Notice of Meeting and Agenda Local Review Body.

| 2 | LRB 02.20 | |
| | Review the Planning Authority's decision to refuse planning permission for the erection of four detached dwelling houses, formation of access road and associated parking at land to east of Brown Street, Stoney Brae, Paisley. (18/0433/PP) | |

FOR PLANNING APPLICATION 18/0433/PP - Erection of four detached dwelling houses, formation of access road and associated parking - Land to East of Brown Street/Stoney Brae

Proposed Access Arrangements & Visibility Splays

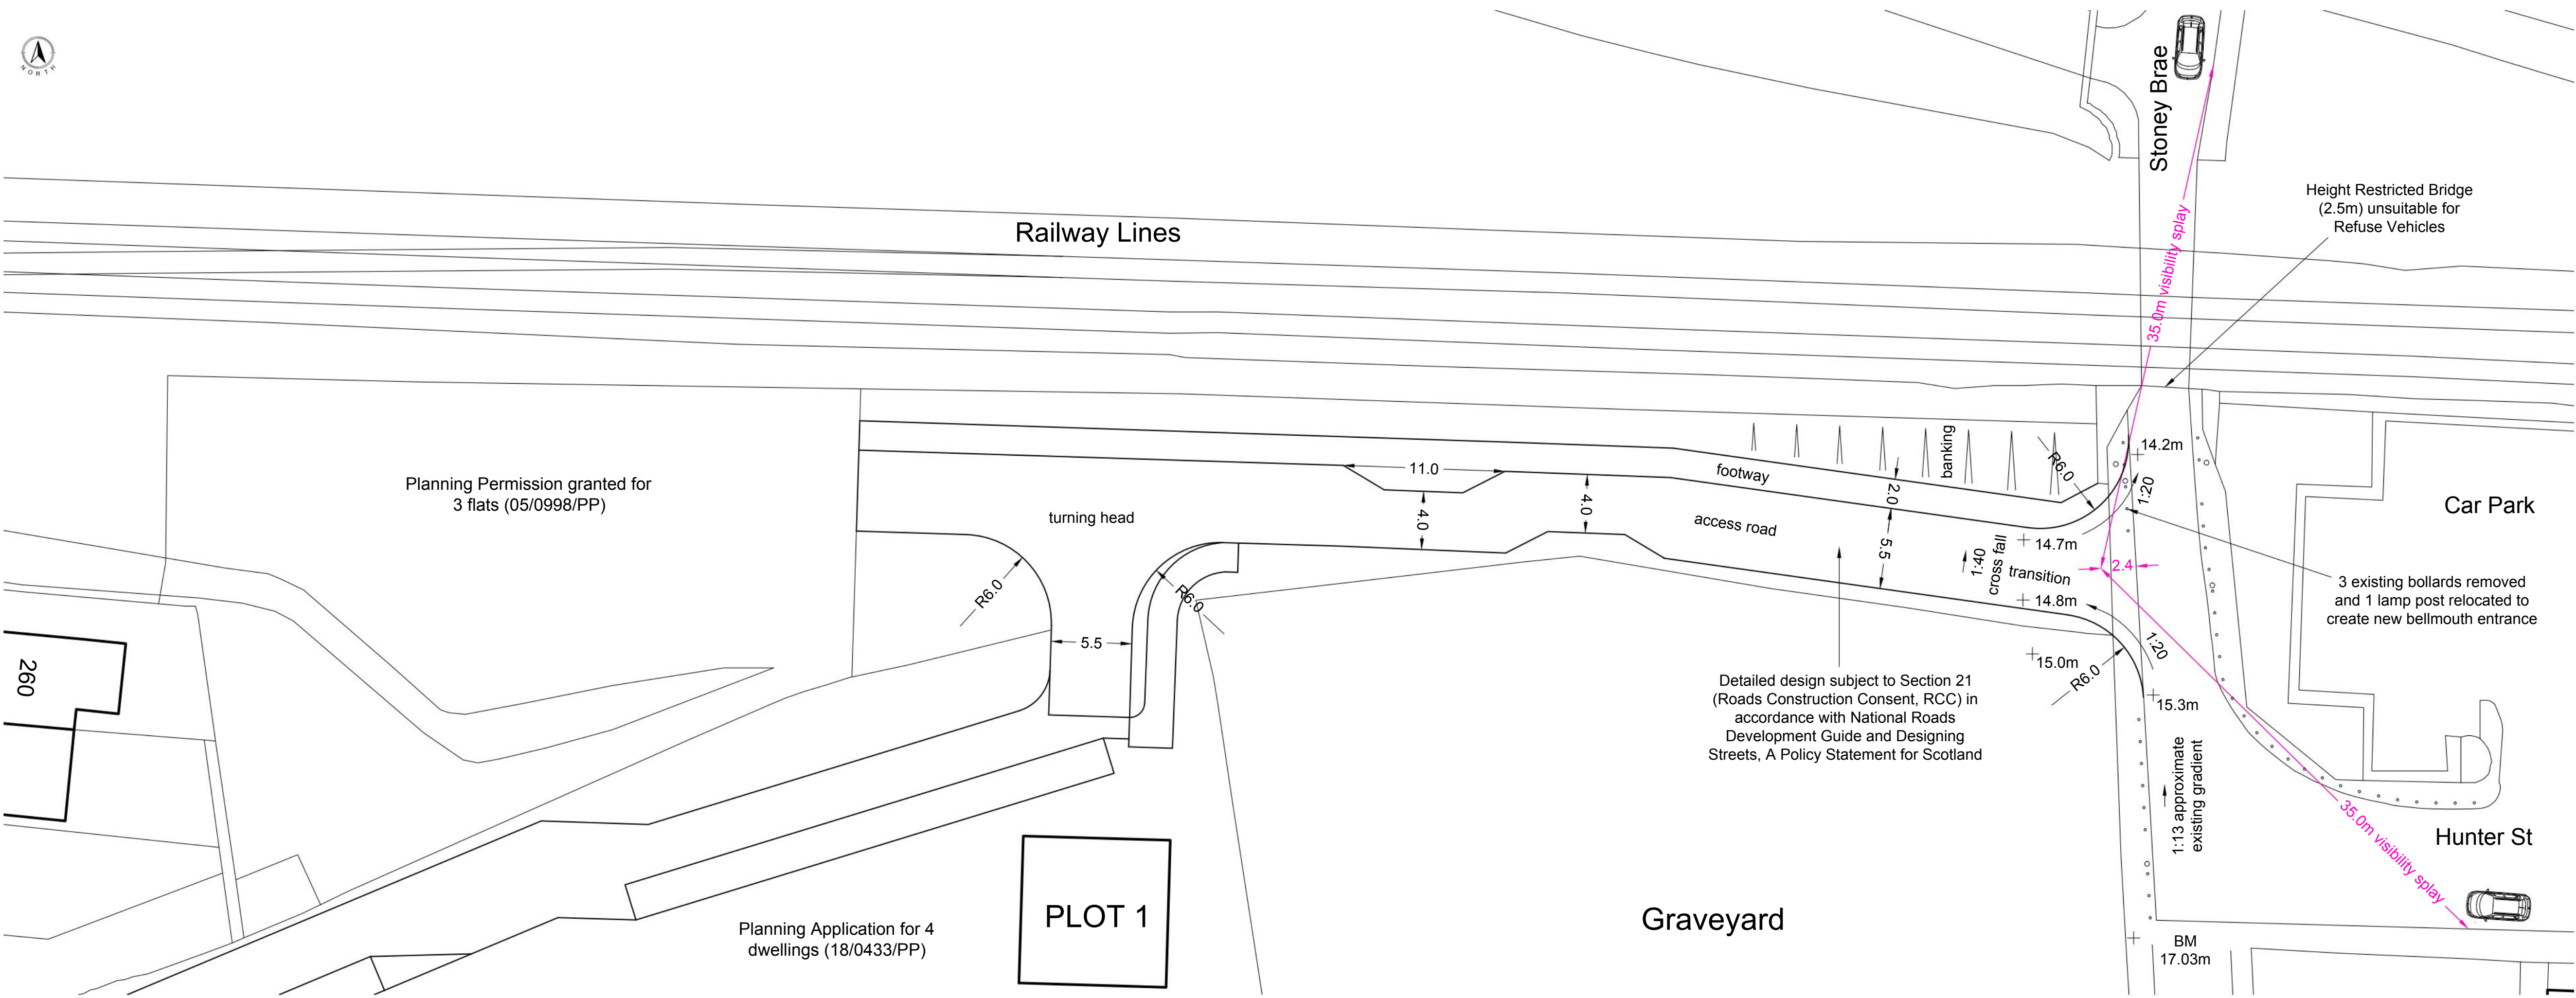
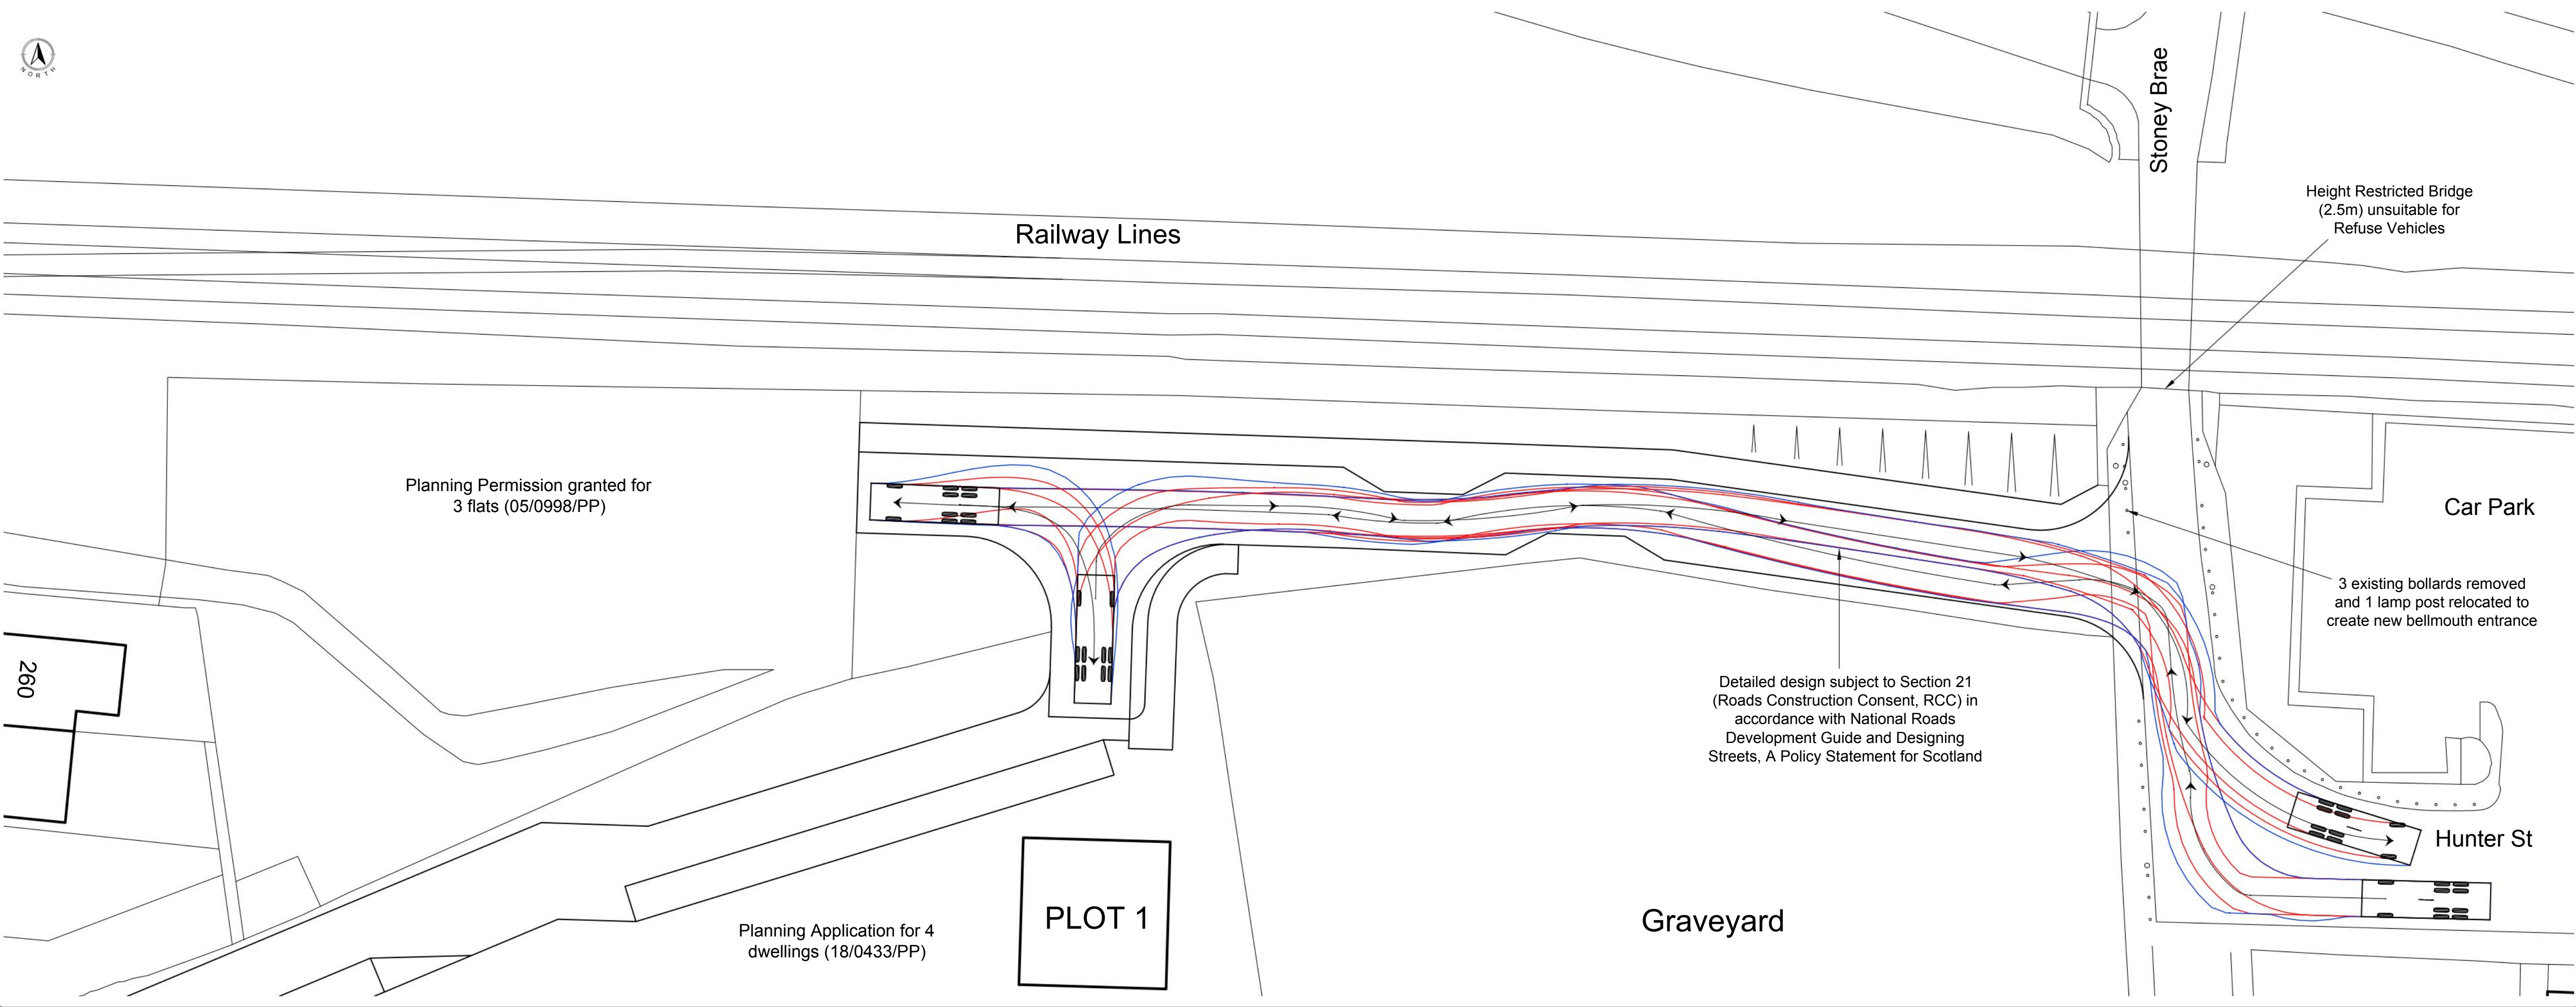
3. "... I additionally reiterate that confirmation of the 35m forward	<p>This Visibility Requirement was requested per email received 22nd January 2019, as a pre-requisite for at least 20m clear sightline – see stated below Table 4 item No10, as Pre-Condition for previously approved Planning Permission 10/0701/pp, (2011):</p>	<p>35m forward visibility is noted in drg Drawing A4187 No.1 Rev. A- no further comment</p>

4. "... appears ok horizontally but I still need swept paths and as above long sections of the centerlines and wheel lines..."	COMPLIED - ACKNOWLEDGED	No further comment
"... gates and stop line are now removed..."	COMPLIED - ACKNOWLEDGED	No further comment

4. "... swept paths still outstanding..."	COMPLIED - PROVIDED WITH OUR DRAWINGS (A4187- No.1, and No.2 – see here attached)	No further comment
5. "... please confirm if it is the intention to link the footways shown in sketches 1 and 3 as it seems to be missing in sketch 2	YES, that is the correct intention

Layout Plan
Scale 1:250

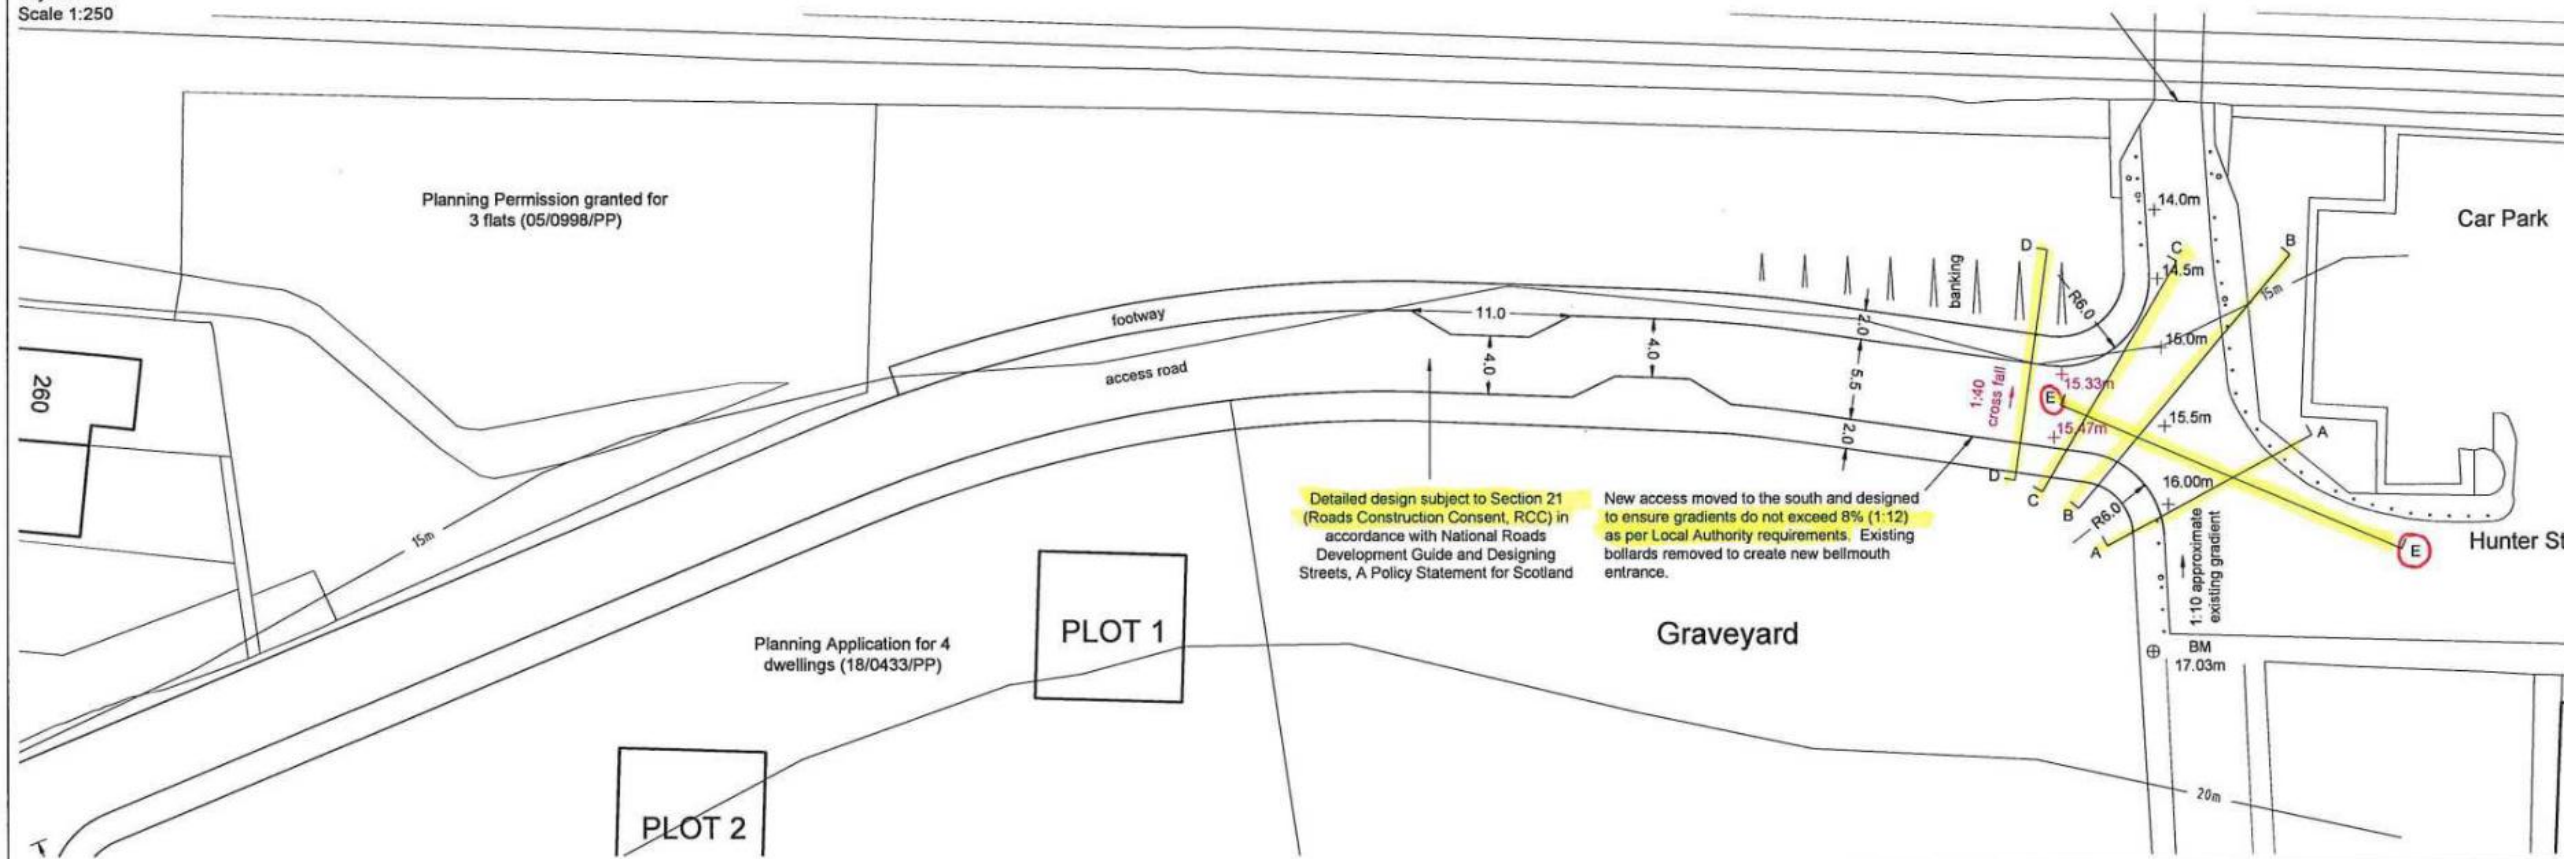
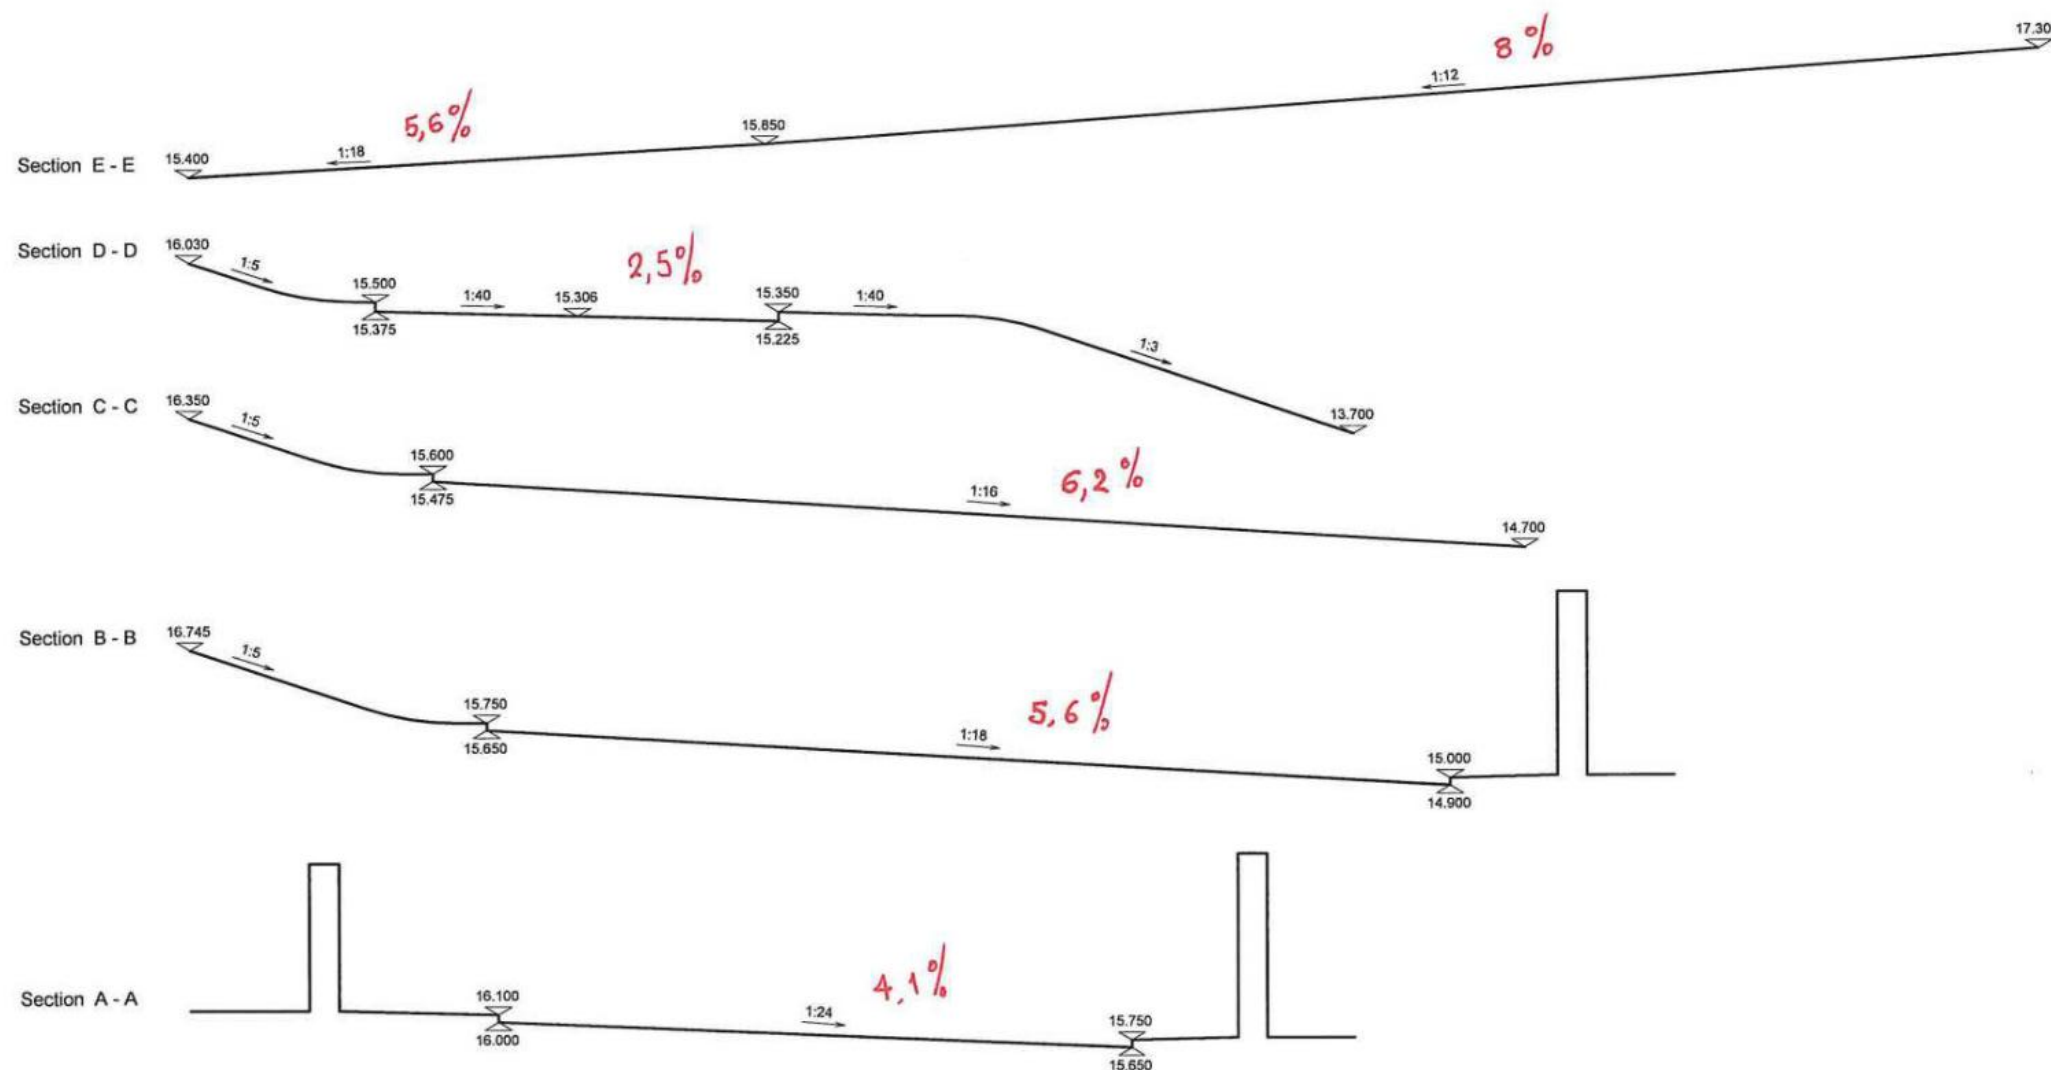
Initial Comments issued by Roads Planning Officer per email 24th June 2019	Response by Owner/ Developer Submitted 24 th July 2019	Roads Department Response received 21-9-19
<p>1. "... Before I can proceed, I need vertical alignment information including an assessment to demonstrate that a high sided vehicle such as a bin lorry will not tip over when making the maneuver..."</p>	<p>1. To demonstrate that high sided vehicles such as a bin lorry will not tip over when making the maneuver, we are providing here our revised Drawing A4187 No.2 Revision A, with <u>Swept Path Analysis</u>, and including <u>5 additional Sections</u>, taken at the entrance junction with Hunter St, which demonstrate the following:</p> <p>1.1. the new proposed junction allows the Bin Lorries to enter directly into the Old Graveyard from Hunter St., which means that the Bin Lorry will not need to descend down Stoney Brae and will not need to turn 90 degrees left, but instead will enter directly into the site entrance opposite Hunter St., therefore high sided Bin Lorries will not tip over when making the maneuver.</p> <p>1.2. <u>All centerlines follow in parallel with natural contour lines and thus achieve less than 8% or (1:12) gradient, shown with Longitudinal Section E-E', along centerline at junction with Hunter St. The gradients range from 5% to 6.2% max, not exceeding 8% or (1:12) in compliance with National Road guidelines.</u></p> <p>1.3. At the proposed junction with Hunter St., the cross-fall gradients along <u>Sections A-A', B-B' and C-C'</u> in likewise range from 4% to 6.2% max, and do not exceed at any point that of 8 %, in line with National Road guidelines.</p> <p>1.4. At the entrance point to the old Graveyard, the Crossfall of the internal road smoothens out to 2.5% or (1:40) with <u>Section D-</u></p>	<p>No sections are shown on Drawing A4187 No.2 Rev. A</p> <p>The is insufficient information on the drawing to demonstrate or prove this</p> <p>There is no level information on the drawings only contour lines which re inaccurate as they continue over retaining walls with no change in level shown whilst there is obvious change in levels on site – Until detailed levels are shown no further comment can be made</p> <p>No sections are shown- perhaps these are on another drawing</p>

<p>2. “... Before though considering vehicles, we need to consider pedestrians and I would also need to see a footway being proposed on the south side of the new junction ...”</p>	<p>Separate 2m Footways are provided either side along the full length of the access entrance road, both to the North and to the South, as depicted on our revised <u>Drawing A4187 No.2 Rev. A</u>, here attached</p>	<p>Drawing A4187 No.2 Rev. A shows a discontinuous footway only on the north side terminating at plot1</p>
<p>3. “... I additionally reiterate that confirmation of the 35m forward sightline comes from would be nice...”</p>	<p><u>This Visibility Requirement was requested per email received 22nd January 2019, as a pre-requisite for at least 20m clear sightline – see stated below Table 4 item No10, as Pre-Condition for previously approved Planning Permission 10/0701/pp, (2011):</u></p> <p><i>“... A minimum forward visibility sightline of 20m will be required. (reduced from 35m on account of the area being traffic calmed...”</i></p> <p>3.1. Since our present development plan is an exact reproduction of this initially approved Permit 10/0701 (with improvement to the entrance road access), therefore this visibility condition was carried over as a standing requirement.</p> <p>3.2. To justify in lay-terms a 35-meter clear line of visibility is considered a safe warning distance for vehicles travelling at 28mph. Moreover, in this location, from a practical point of view, vehicles are not able to travel at a speed of 28 mph, since this is a historical area with cobble paved avenues, and not a main traffic route. Since speed limit is restricted, hence 35-meter visibility line is considered sufficient for vehicles exiting the site access.</p>	<p>35m forward visibility is noted in drg Drawing A4187 No.1 Rev. A- no further comment</p>

2. "... separate 2 m footway..."	Separate 2m Footways are provided either side along the full length of the access entrance road, as depicted on revised Drawing A4187 Rev. A, here attached	Not on the accompanying plans unfortunately
